# International Aero Engines SERVICE BULLETIN

NACELLE - NOSE COWL - FORWARD BULKHEAD ANTI-ICE DUCT CONNECTION -ADDITION OF POSITIVE RETENTION FEATURE

> MODEL APPLICATION V2500-D5

V2500-NAC-71-0193 Page 1 of 21

Nose Cowl T.A.I Duct-to-Forward Bulkhead Connection Inspection Figure 2

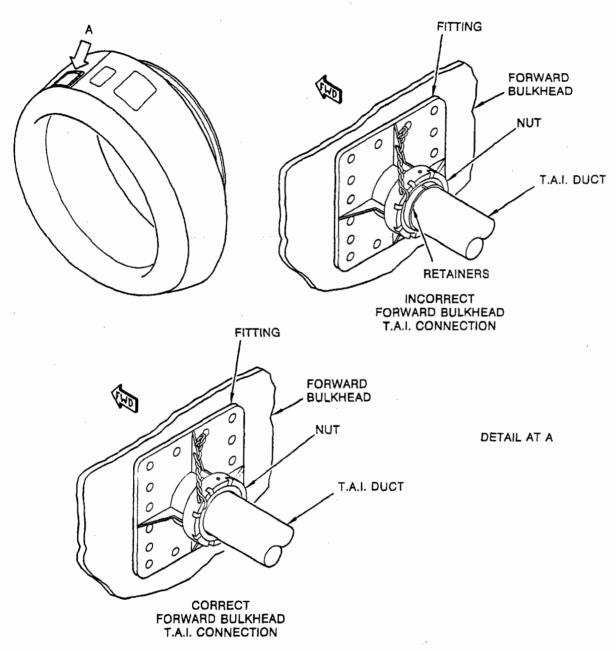
- (1) If you can see the retainers behind the T.A.I. duct nut, the installation is incorrect, and you must do Part 3 of this Service Bulletin. Refer to Figure 2.

- (2) If you cannot see the retainers behind the T.A.I. duct nut, the installation is correct, and you must do Part 2 of this Service Bulletin. Refer to Figure 2.

T.A.I. DUCT REMOVAL/INSTALLATION FIGURE 3 (SHEET 1)

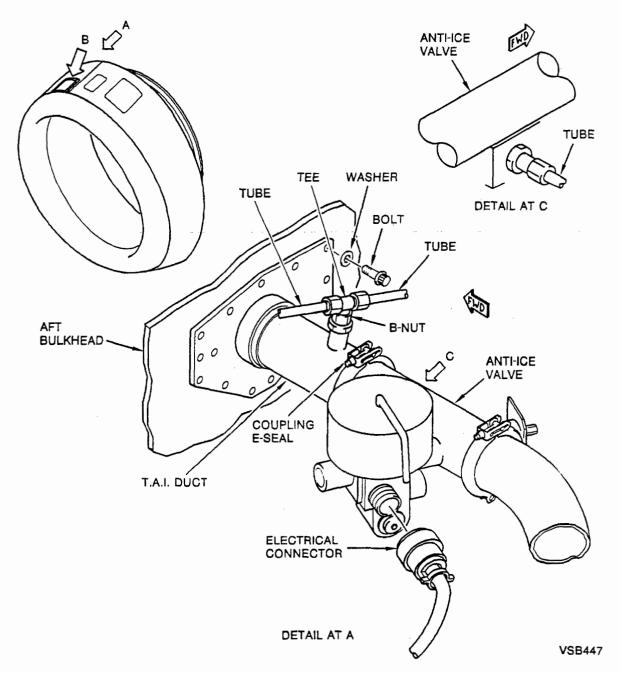
- (1) Disconnect the tubes from the tee on the T.A.I. duct. Then loosen the b-nut and remove the tee. Refer to Figure 3 (Sheet 1).
- (2) Disconnect the tube from the anti-ice valve.
- (3) Disconnect the electrical connector from the anti-ice valve.
- (4) Remove the couplings, e-seals and anti-ice valve from the T.A.I duct.
- (5) Remove the bolts and washers that attach the T.A.I duct to the aft bulkhead.
- (6) Remove the lockwire from the T.A.I. duct nut. Refer to Figure 3 (sheet 2).
- (7) Disconnect the T.A.I. duct nut from the forward bulkhead fitting.
  - NOTE: There are three retainers under the T.A.I. duct nut.

- (20) Install the tee in the T.A.I. duct. Tighten the b-nut to a torque of 200-250 lbfin (23-28 Nm). Refer to Figure 3 (sheet 1).
- (21) Install the tubes on the tee. Tighten the b-nuts of the tubes to a torque of 200-210 lbfin (23-24 Nm).

T.A.I Duct Removal/Installation Figure 3 (Sheet 2)

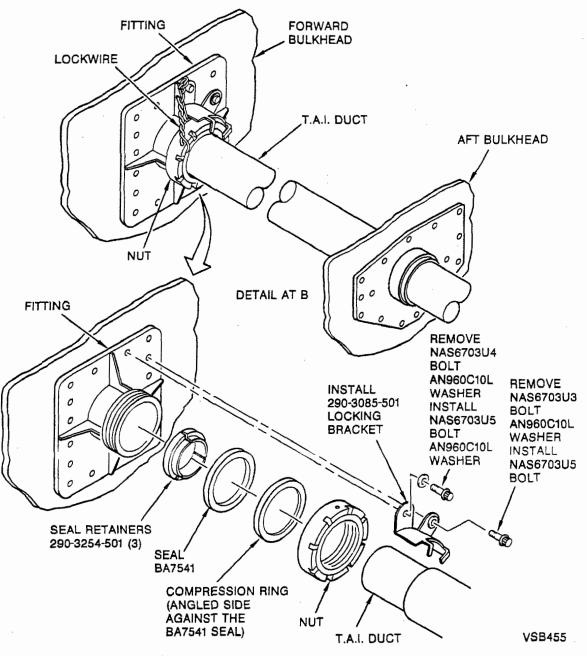
- C. Modification Procedures Part 2
  - (1) Remove the safety wire from the T.A.I. duct nut. Refer to Figure 3 (sheet 2).
  - (2) Disconnect the T.A.I. duct nut from the forward bulkhead fitting.

(7) Remove the NAS6703U3 and NAS6703U4 bolts and two AN960C10L washers from the forward bulkhead fitting as shown in Figure 3 (Sheet 2). Discard the bolts. Keep one washer for installation.

- Mix the primer base (CoMat 07-071), primer converter (CoMat 07-067), and thinner (CoMat 07-066). Refer to the manufacturer's instructions.
- Install the 290-3085-501 locking bracket with the two NAS6703U5 bolts and one AN960C10L washer. Wet install the bolts with the primer mix. If necessary, use the spanner wrench and torque wrench to turn the T.A.I. duct nut in the tightening direction until the slots on the nut align with the locking bracket (not to exceed 50 ftlb (600 inlbs.) of torque) (refer to step (6) to find the actual torque wrench indication). Tighten the bolts to a torque of 34-44 lbfin (3.84-4.97 Nm).
- (10) Safety the T.A.I. duct nut with 0.036 inch diameter or thicker lockwire (CoMat 02-128). Install the lockwire with a minimum 45 degree wrap in the tightening direction. Refer to Figure 3 (Sheet 2).

- (19) Safety the T.A.I. duct nut with 0.036 inch diameter or thicker lockwire (CoMat 02-128). Install the lockwire with a minimum 45 degree wrap in the tightening direction. Refer to Figure 3 (Sheet 2).

T.A.I. Duct Forward Bulkhead Nut Spanner Wrench Figure 4

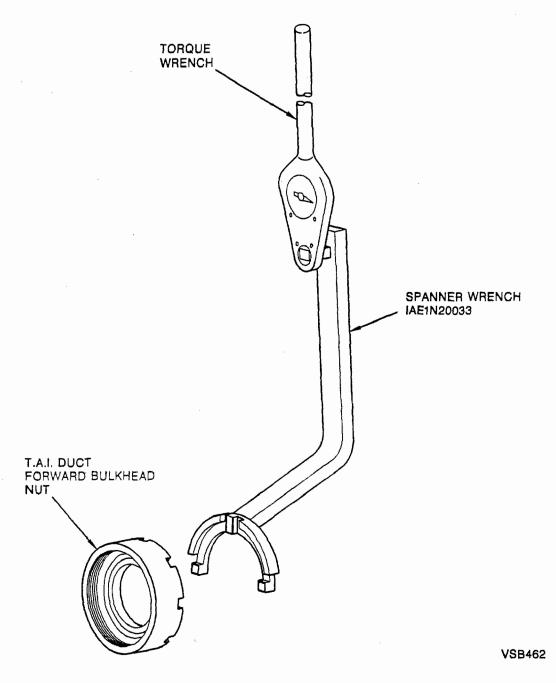
(6) Torque the T.A.I. duct nut to 45 ftlbs (540 inlbs). You must use the IAE1N20033 spanner wrench and torque wrench as shown in Figure 4 to properly torque the nut. The actual indication on the gage of your torque wrench will depend upon the torque wrench length. Use the following formula to determine the proper torque wrench indication:

- A = 10 inches; the distance from the center of the square drive hole in the IAE1N20033 spanner wrench to the centerline of the T.A.I. duct forward bulkhead coupling nut.
- L = Distance from the centerline of the torque wrench drive to the center of the operators hand. Refer to Figure 4.

- (16) Torque the T.A.I. duct nut to 45 ftlbs (540 inlbs). You must use the IAE1N20033 spanner wrench and torque wrench as shown in Figure 4 to properly torque the nut. The actual indication on the gage of your torque wrench will depend upon the torque wrench length. Use the following formula to determine the proper torque wrench indication:

L = Distance from the centerline of the torque wrench drive to the center of the operators hand. Refer to Figure 4.
